UNITED STATES PATENT AND TRADEMARK OFFICE

APPLICATION NO.	FILING DATE	FIRST NAMED INVENTOR	ATTORNEY DOCKET NO.	CONFIRMATION NO.
10/019,195	06/03/2002	Hans-Jurgen Hannig	09646-00004	6251

Office Action Summary

FR-2,278,876

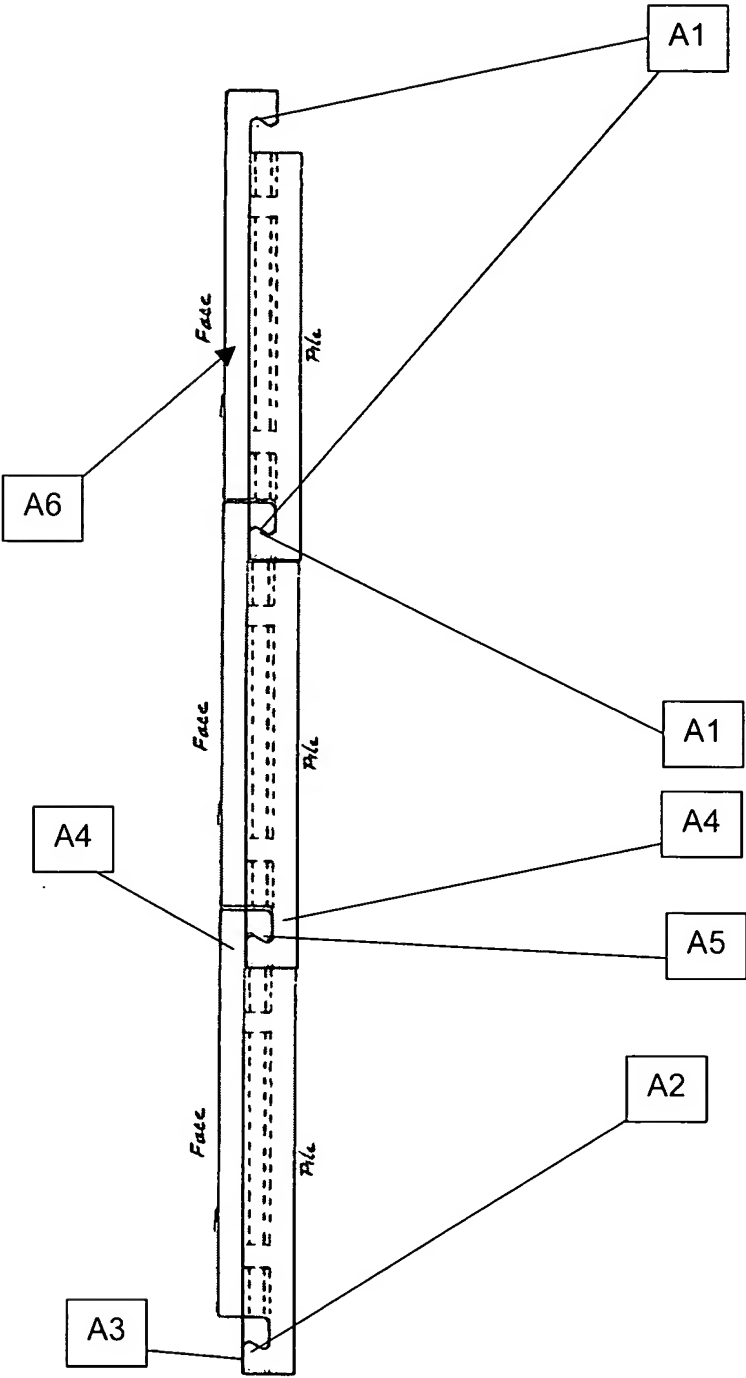
Claims 1, 2, 4 and 30 are rejected under 35 U.S.C. 102(b) as being anticipated by the French patent, 2,278,876 (see marked-up attachment).

Regarding claim 1, as best understood, the French patent discloses, in unlabeled figure, a fastening system characterized in that retaining surfaces **A1** of hook projections **A2** and complementary hook projections **A5** are inclined. The hook projections **A2** are reduced from free ends **A3** towards legs **A4**. One of the hook projections **A2** bears against the retaining surfaces **A1** of the complementary hook projections **A5**.

Regarding claim 2, as best understood, a first retaining profile of at least one pair of oppositely disposed retaining profiles is provided with a hook element formed from the leg. The leg projects approximately perpendicularly from the narrow side of the panel and arranged at a top side of the panel. A hook projection **A2** is arranged at the free end of the leg. The hook projection faces towards an underside of the panel. A second retaining profile of at least one pair of oppositely disposed retaining profiles is opposite the first retaining profile and provided with a hook element formed from the leg. The leg projects from the narrow side of the panel and arranged at an underside of the panel. A hook projection **A2** is arranged at the free end of the leg of the second retaining profile. The hook projection faces towards the top side of the panel.

Regarding claim 4, as best understood, the retaining surfaces **A1** engage with the complementary hook projections **A5**. Applicant is reminded that the method of engaging the retaining surfaces **A1** with the complementary hook projections **A5** is not germane to the issue of patentability of the device itself. Therefore, this limitation has been given limited patentable weight. See MPEP ' 2113.

Applicant has argued that the figure provided by the Examiner does not appear in the French publication. Applicant is correct. The examiner merely fabricated what is suggested by the specification (see attachment of the English abstract). It is inherent that several tiles make-up a floor covering. One of ordinary skill in the art will readily know that putting tiles of the French patent together make-up a floor covering as shown
